Subject: Front Brake Hose Rework			
Field Change Program: Field Campaign	FCP Number: 481	Revision: A	Date: 06/24/2020
Coach Section: 04-Brakes & Air system	P/N: 04-20-1817		Type: Safety Recall

Ref. NHTSA Recall No.: 20V-233	Ref. Transport Canada Recall No.: 2020-179
--	--

Motor Coach Industries (“MCI”) has become aware that on certain J4500 and J3500 model coaches, the front brake hoses may crack or otherwise fail due to their routing and clamping orientation, resulting in air leaking from the hose. As a result, brake performance could be affected. Reduced brake performance can cause extended stopping distances and increase the risk of a crash.

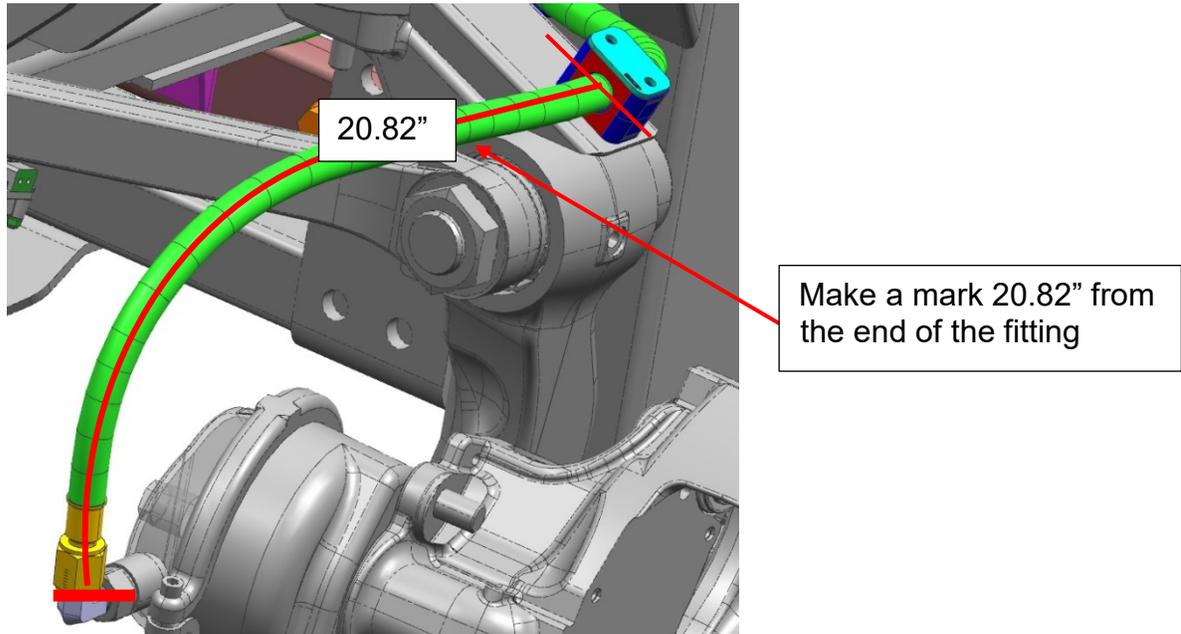
Identify the fitting on the side of the long spring guard on the new brake hose, MCI P/N: 04-20-1890.

Apply two drops of thread sealer, MCI P/N: 23-06-0070, to the previously identified end of the brake hose and install it to the 90-degree fitting on the front brake chamber. Hold the 90-degree fitting on the front brake chamber tight with a wrench while tightening the brake hose. Torque the brake hose fitting to 58 Ft-Lbs.

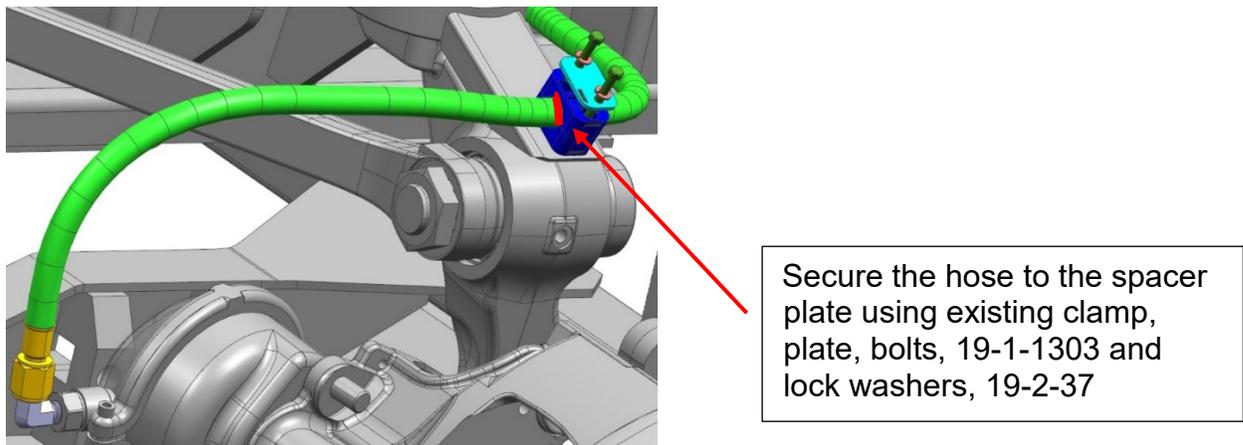
Make a mark on the hose at 20.82" from the end of the fitting and align it with the front face of the A-post clamp.

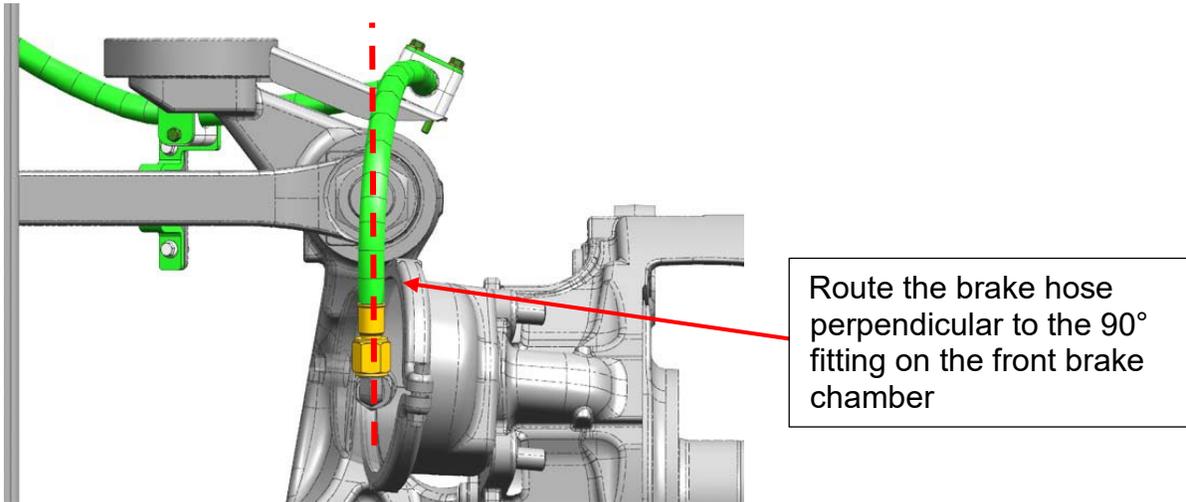
Re-install the existing A-post clamp and plate using bolts, MCI P/N: 19-1-1303, and lock washers, MCI P/N: 19-2-37. Ensure the long spring section is completely between the fitting and the clamp and is not compressed on areas of the hose assembly with spring guard. Torque the bolt to 9 Ft-Lbs.

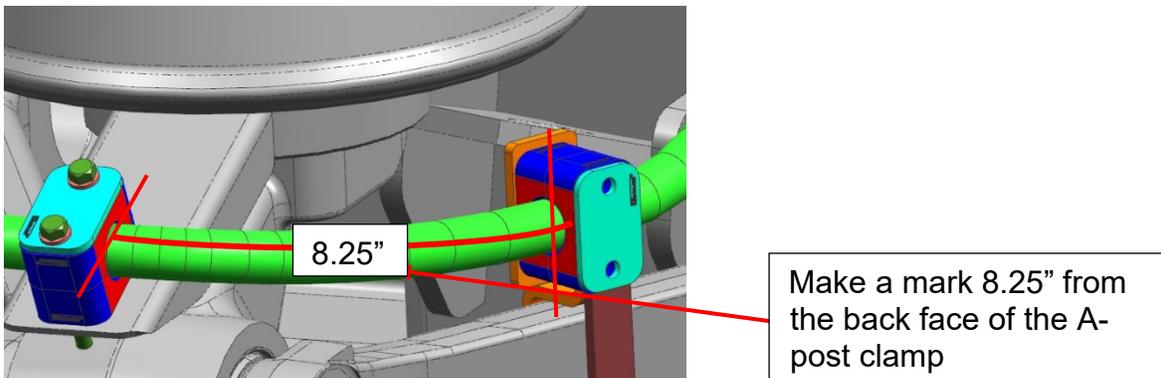
Ensure that the hose between the front brake chamber and A-post clamp is routed perpendicular to the 90° fitting on the front brake chamber.

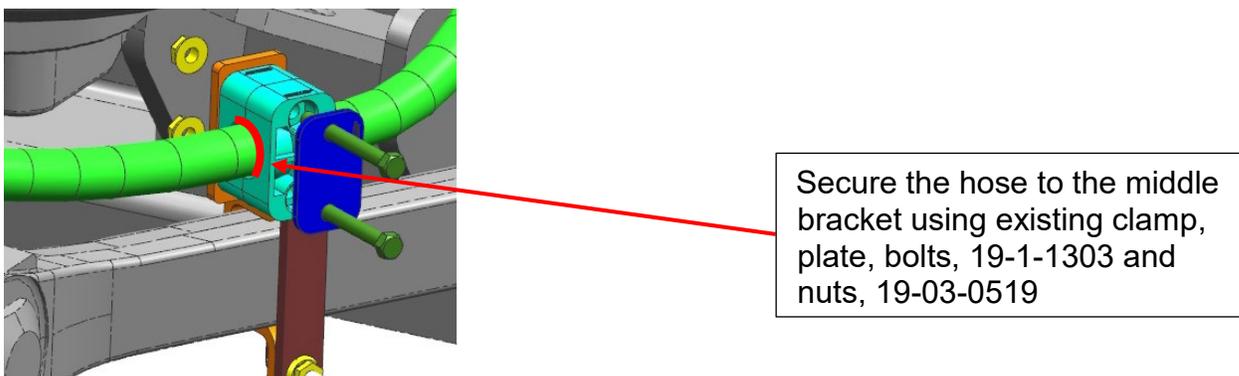
Make a mark on the hose at 8.25" from the back face of the A-post clamp and align it with the front face of the middle clamp.

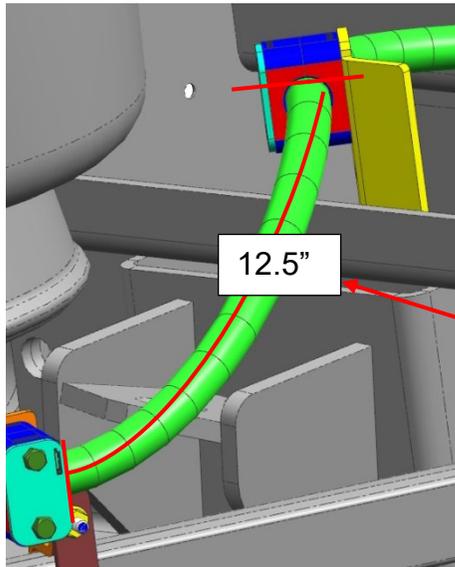
Re-install the existing middle clamp and plate using bolts, MCI P/N: 19-1-1303, and nuts, MCI P/N: 19-03-0519. Ensure the middle section of the spring is between the clamps and is not compressed on areas of the hose assembly with spring guard. Torque the nuts to 9 Ft-Lbs.

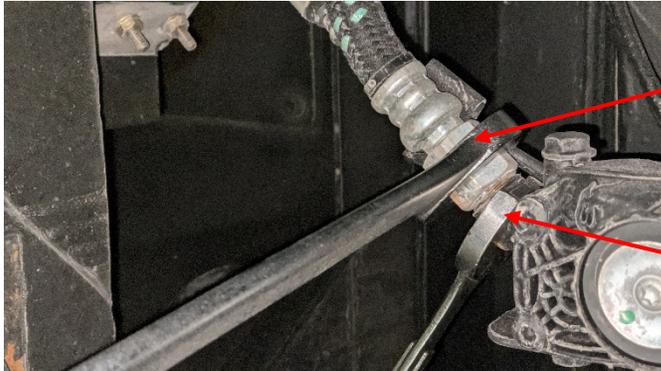
Re-install the existing frame bogie clamp and plate using bolts, MCI P/N: 19-1-1303, and nuts, MCI P/N: 19-03-0519. Ensure the short section of the spring is between the clamps and is not compressed on areas of the hose assembly with spring guard. Torque the nuts to 9 Ft-Lbs.

Secure the hose to the welded bracket on the frame using existing clamp, plate, bolts, 19-1-1303 and nuts, 19-03-0519

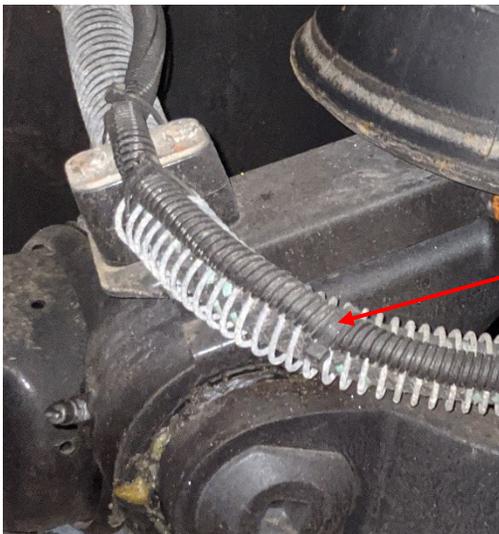
Apply two drops of thread sealer, MCI P/N: 23-06-0070, to the fitting on the free end of the brake hose and install it to the ABS front module relay valve. Hold the fitting on the BAS front module relay valve with a wrench while tightening the hose. Torque the fitting to 58 Ft-Lbs.

Install the free end of the hose to ABS front module relay valve

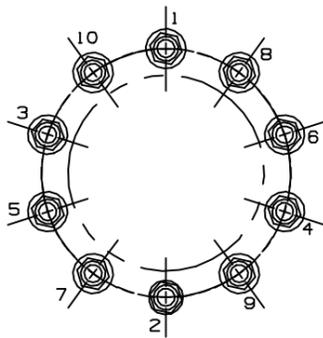
Secure the ABS sensor harness to the front brake hose using cable ties, MCI P/N: 19-11-258. Use as many cables ties as required to secure the harness.

Secure the ABS sensor harness to the front brake hose using cable ties, 19-11-258
